ISSUE 3, 1984 : DISK DRIVE 2

Model: 1541

PCB Assembly #1540048 (Schematic 1540049) requires an upgrade to the reset circuit. The upgrade consists of:

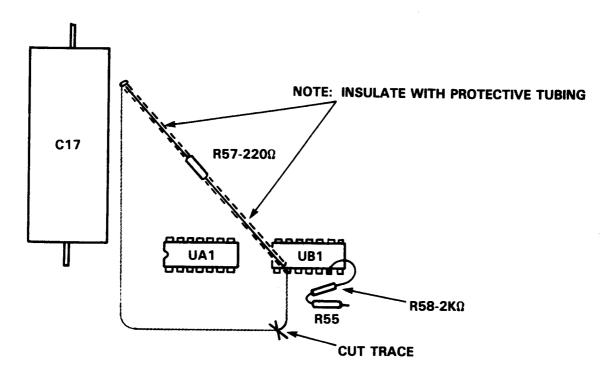
1) COMPONENT CHANGES:

R25 Change To 6.8K ohm, 1/4 W, +/-5%R57 Add 220 ohm, 1/4 W, +/-5%R58 Add 2K ohm, 1/4 W, +/-5%

2) CUT circuit trace near UA1 (See diagram)

3) INSTALL JUMPER WIRES:

BETWEEN:

UA1 pin 8 and UB1 pin 5 UA1 pin 9 and CR7 Anode

UB1 pin 6 and UD3 pin 5 on BACK of board

4) CUT circuit trace between CR7 Anode and UD3 pin 5 on BACK of board.
